ADDENDUM 1 TO THE CONTRACT PROVISIONS AND CONTRACT PLANS

NORTHSHORE UTILITY DISTRICT LAKEWOOD VILLA WATER AND SEWER IMPROVEMENTS

G&O #23625.00

ISSUED THIS DATE: FRIDAY, JULY 25, 2025

SHEET 9, SEWER MANHOLE PLAN

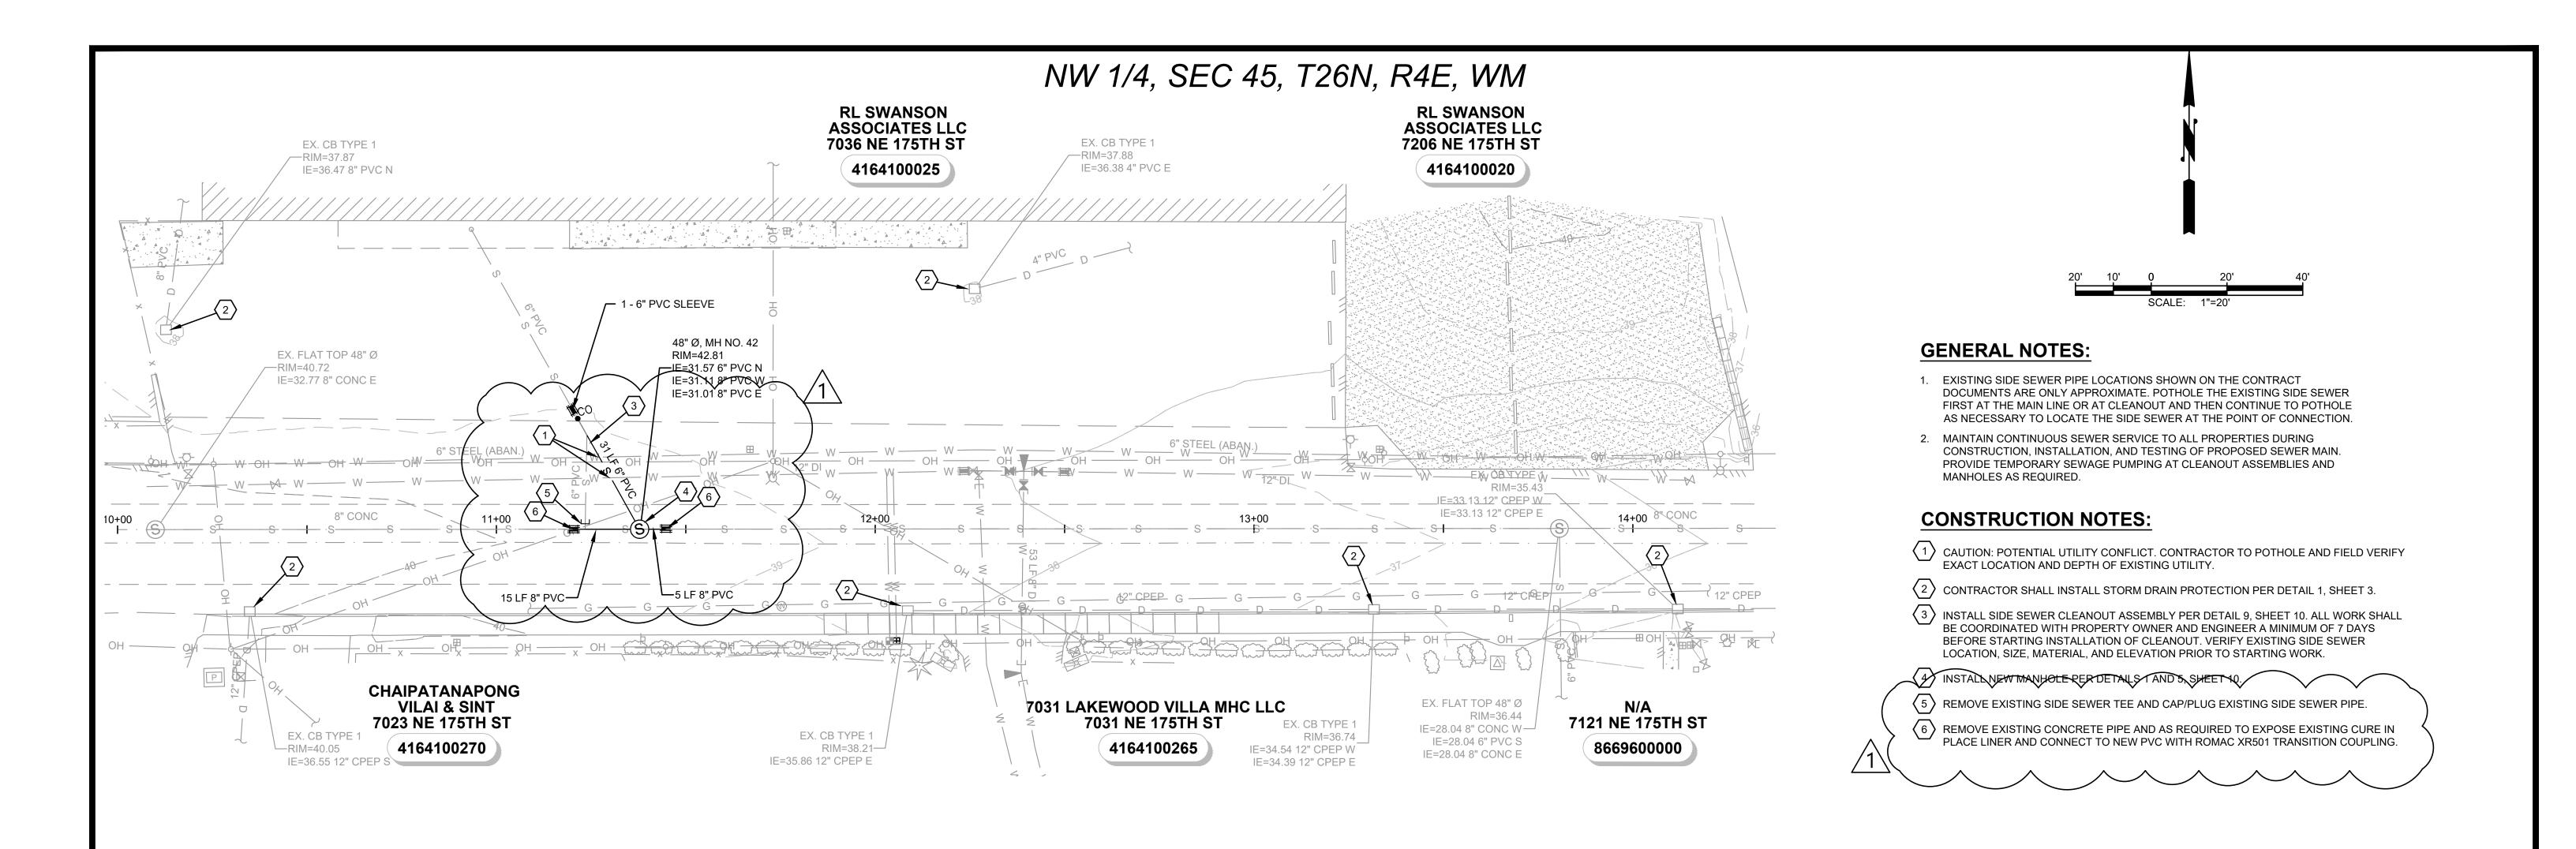
MODIFY the Plan as shown in the attached Addendum Drawing No. 1.
